Subject: Important Medical Device Information – INGEVITY™ MRI active fixation pacing lead manual - Ref. 92160868-FA

Appendix A: Summary of INGEVITY Active Fixation Physician Lead Manual Updates

Table 1: Updates to INGEVITY MRI Active Fixation Physician’s Lead Manual

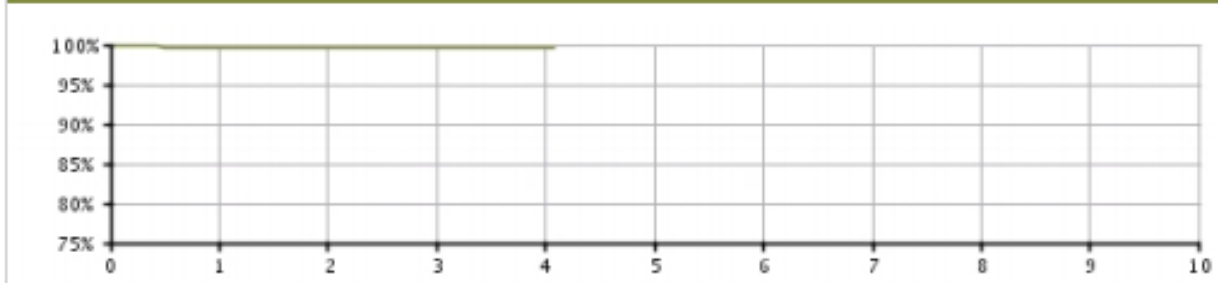
Location in <i>Physician’s Lead Manual</i>	Labeling Updates
Information for Use: Precautions AND Implantation: Handling the Fixation Helix	Do not overextend or over-retract the helix. Do not overextend or over-retract the helix. The lead conductor coil or fixation mechanism can be damaged or broken if you continue to rotate the terminal pin once the helix is fully extended or retracted.
Information for Use: Precautions AND Implantation: Handling the Fixation Helix and Lead Fixation	Avoid creating sharp bends while extending or retracting helix. Avoid creating sharp bends in the lead terminal or lead body while extending or retracting the helix. Sharp bends can increase the risk of breaking the conductor coil or fixation mechanism during helix extension and retraction.
Information for Use: Precautions AND Implantation: Lead Fixation and Repositioning the Lead	Terminal pin maximum number of turns. Do not rotate the terminal pin clockwise or counterclockwise more than the recommended maximum number of turns indicated in the specifications (Table 5 Specifications (Nominal) on page 29). Continuing to rotate the terminal pin once the helix is fully extended or retracted (as indicated by fluoroscopy) can damage the lead, cause a conductor coil break during fixation , cause lead dislodgment, tissue trauma, and/or cause acute pacing threshold to rise.

Implantation / Handling the Fixation Helix section	NOTE: The expected number of turns and the recommended maximum number of turns to extend or retract the helix are provided in the specifications (Table 5 Specifications (Nominal) on page 29). Any curves introduced into the stylet could increase the number of turns needed to extend or retract the helix.
Implantation / Lead Fixation section	NOTE: The number of turns to extend or retract the helix may vary based on patient anatomy and implant conditions. Maintain a straight trajectory coming out of the patient anatomy to the extent feasible.
Implantation / Evaluating Lead Performance	Verify electrical performance of the lead using a pacing system analyzer (PSA) before attaching the lead to the pulse generator. Verifying electrical performance will confirm lead integrity. (Note: This is also proposed for the timed fixation manual.)
Implantation / Electrical Performance	• A discontinuous signal may indicate a lead conductor coil break , fracture or an otherwise damaged lead, or an insulation break that would necessitate lead replacement.

Specifications / Specifications table (Note this CAUTION statement was previously included in the manual and was added to this section of the PLM)	Recommended maximum number of rotations to extend/retract the helix CAUTION: Do not rotate the terminal pin clockwise or counterclockwise more than the recommended maximum number of turns indicated. Continuing to rotate the terminal pin once the helix is fully extended or retracted (as indicated by fluoroscopy) can damage the lead, cause a conductor coil break during fixation, cause lead dislodgment, tissue trauma, and/or cause acute pacing threshold to rise.
